**STATE OF CALIFORNIA  
REGIONAL WATER QUALITY CONTROL  
BOARD CENTRAL COAST REGION**

**STAFF REPORT FOR REGULAR MEETING OF MARCH 7-9, 2017**

**SUBJECT:** Waste Discharge Requirements and Water Reclamation Requirements for the Pure Water Monterey Advanced Water Purification Project, Monterey Regional Water Pollution Control Agency, Monterey County

**This Action:** Adopt Order No. R3-2017-0003

Facilities Location Map

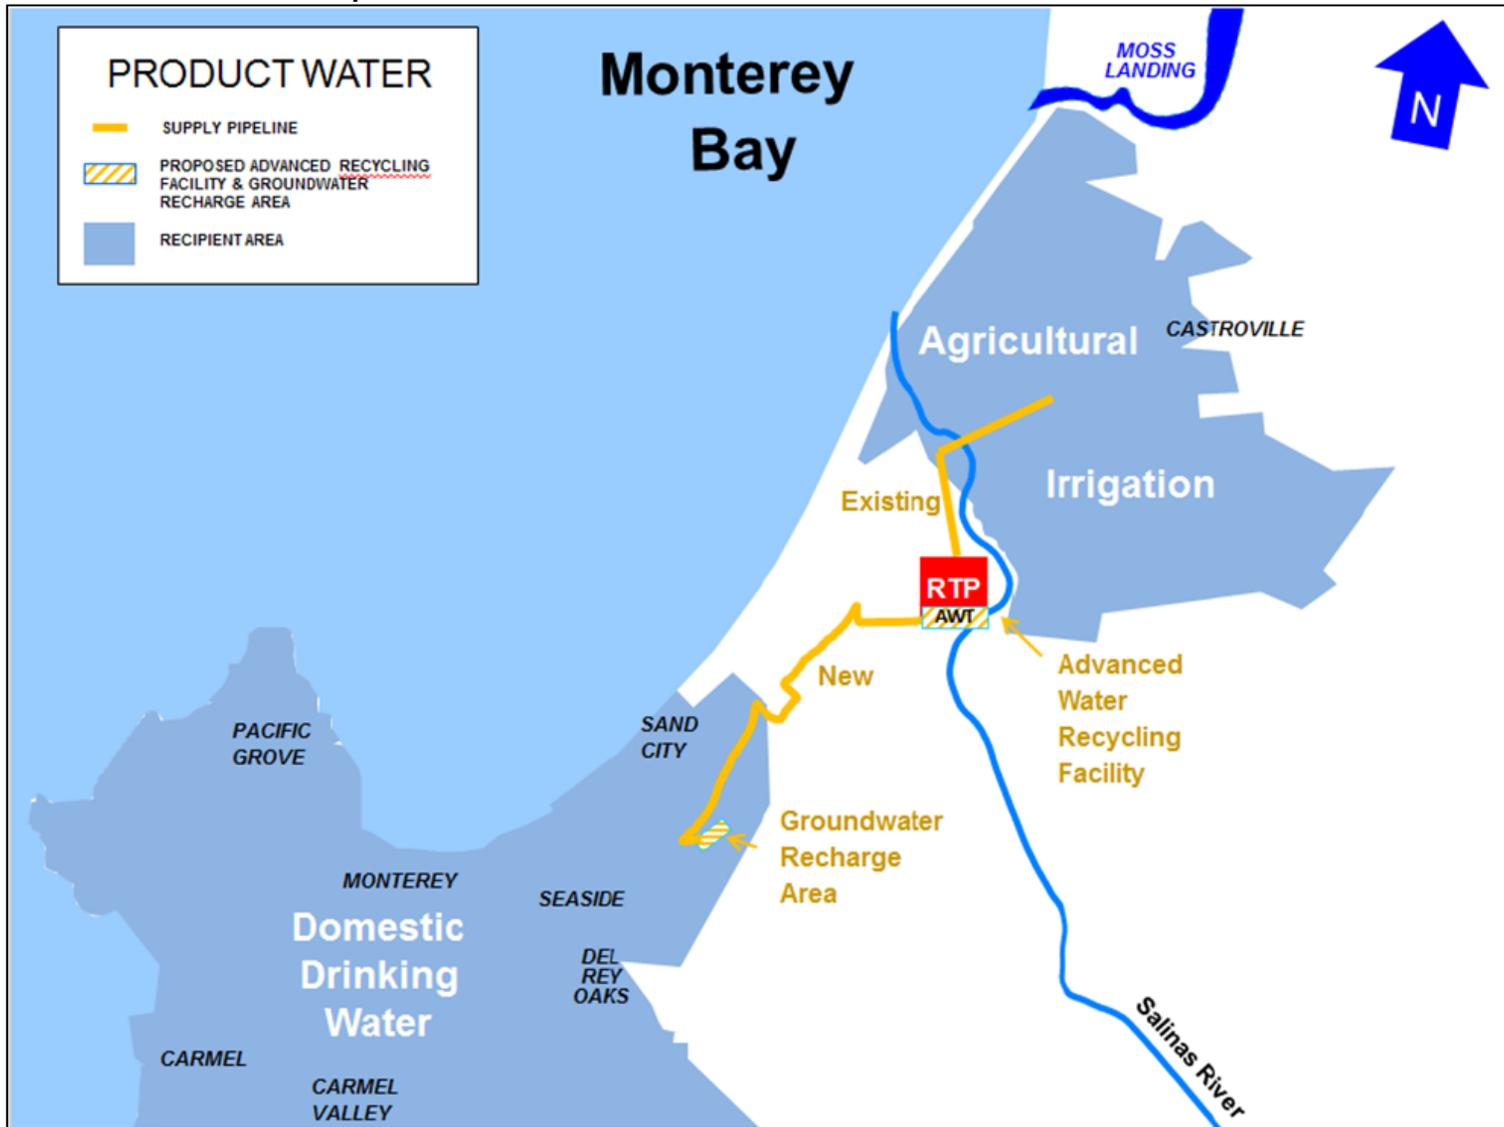
**NS Comment #29: Figure 1 - Location of MRWPCA's RTP, AWTF, and Injection Wells (Page 23)**

Change "RTF" to "RTP"

**Response # 29:** The requested change will be made to the draft Order.
